SERVICE INFORMATION

SERIAL NO. 9006

SUBJECT	Skipping
ITEM	Compact Disc Player
MODEL	DX-1500/DX-2500/DX-M70

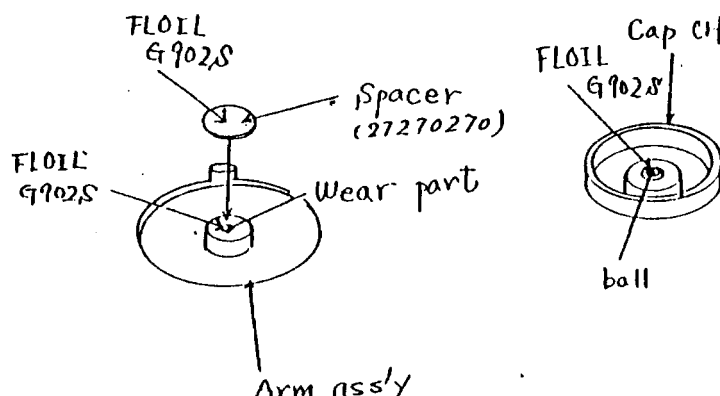
3. Confirmation of pickup slide mechanism

Remove the mechanism and apply 1V DC to the both sides of the slide motor terminal.

Does the pickup go to the outermost position without getting stuck?

5. Is the part of arm ass'y that is touched with the ball of cap CII woreed off?

6. Replace the spring (#20) from 27180341A (170gr) to 27180409 (260gr).

If not, replace the slide motor.

No... Lubricate the grease (FLOIL G902S) on the ball of cap CII and the above mentioned part of arm ass'y.

Yes... Apply the spacer (PN: 27270270) on the above mentioned part of arm ass'y with the bond #575. Apply the grease to the same as above.
